Special Use Application: SU-CFW 23-0750
LUHO Meeting Date: October 23, 2023
Case Reviewer: Tim Lampkin, AICP

1.0 APPLICATION SUMMARY

AGENCY REVIEW COMMENT SHEET

PETITION NO: SU 23-0750

2.4 Proposed Site Plan (partial provided below for size and orientation purposes. See Section 8.0 for full site plan)

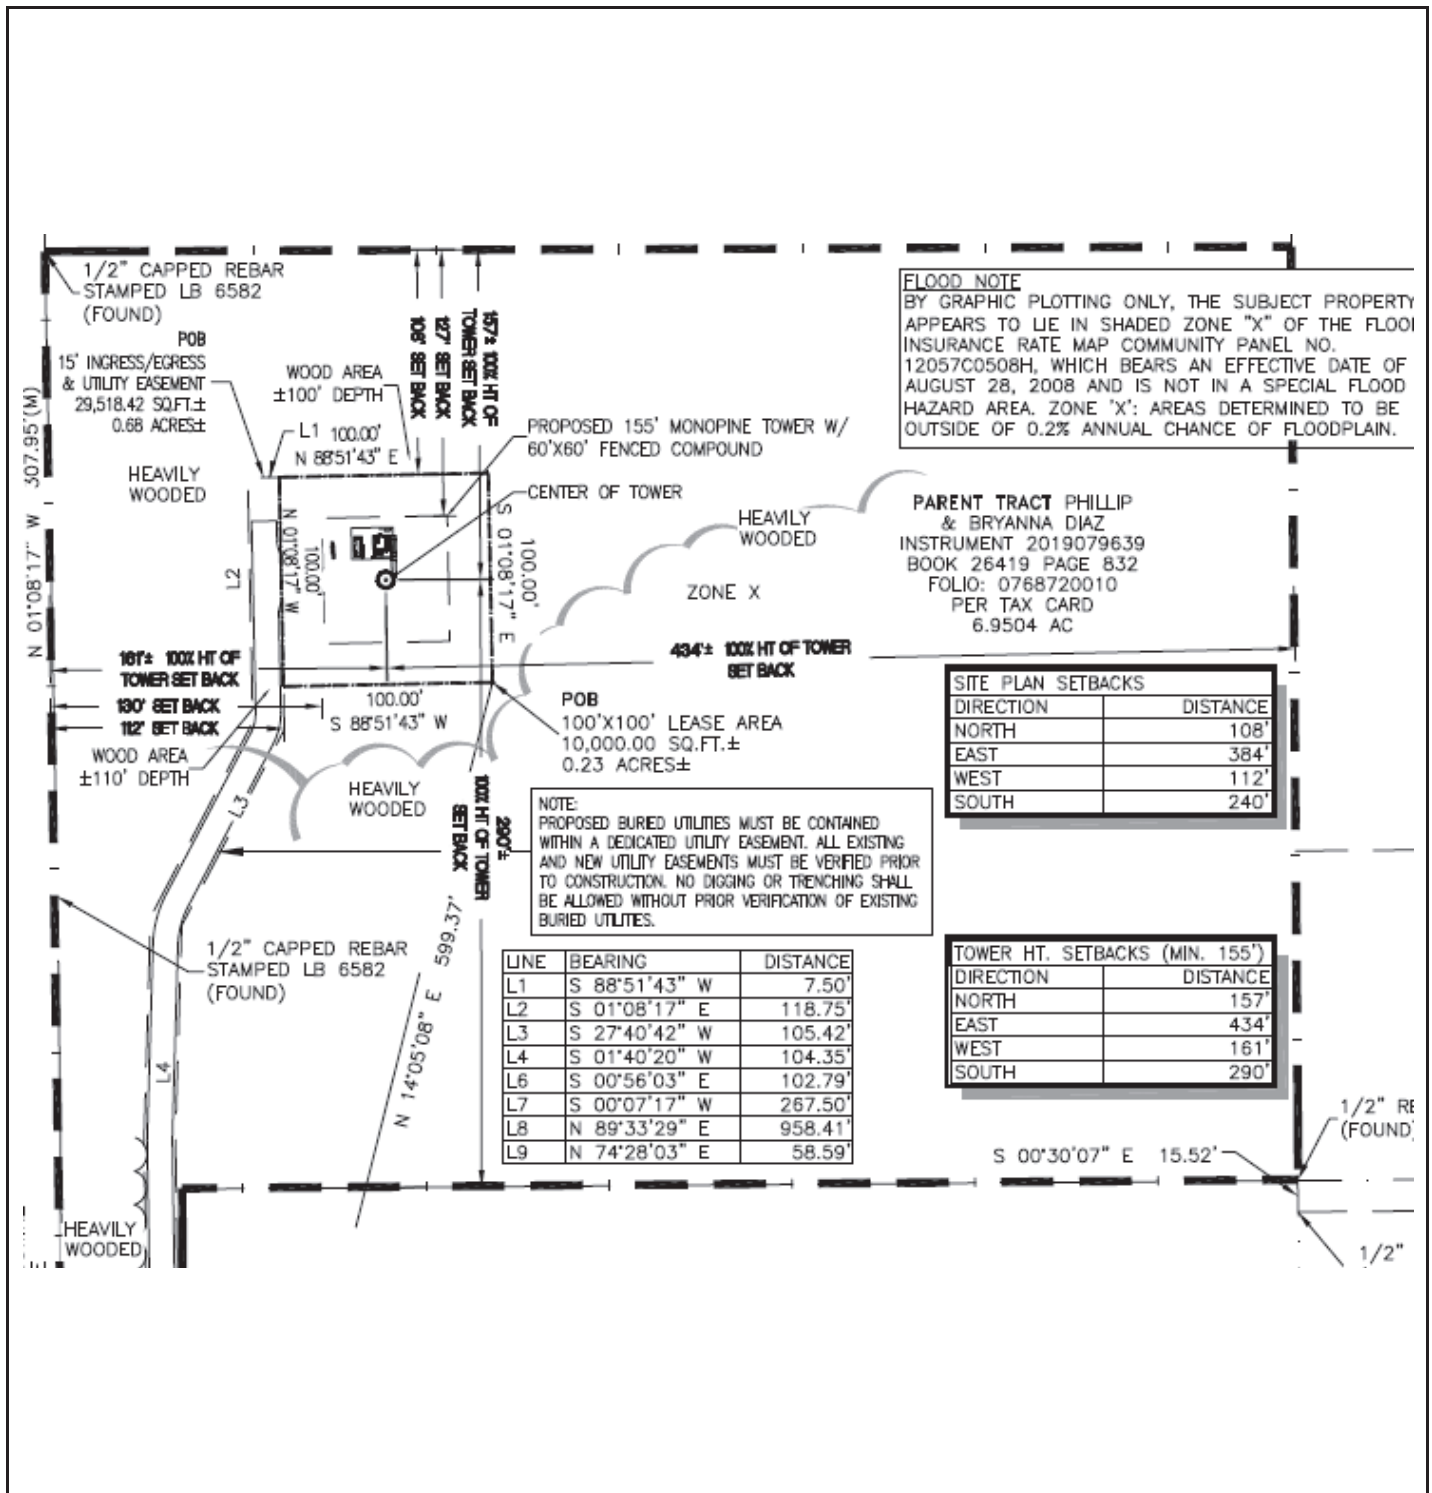
Transportation staff indicated objection to the proposed communication facility subject pursuant to the 15-foot-wide access variance request. Pursuant to LDC Sec. 6.02.01.B.5.c.(2), Transportation staff finds that the width of an easement serving two or three homes shall be a minimum width of 30 feet. Given that the access does not meet minimum standards to accommodate two homes, staff cannot support further addition of trips (regardless of how infrequent they may be) which could create safety and/or operational problems when traffic is unable to pass. As such, Transportation staff cannot support this request.

Based on the above, staff finds the proposed communication facility not supportable due to Transportation's objection and findings that the substandard access is not adequate.
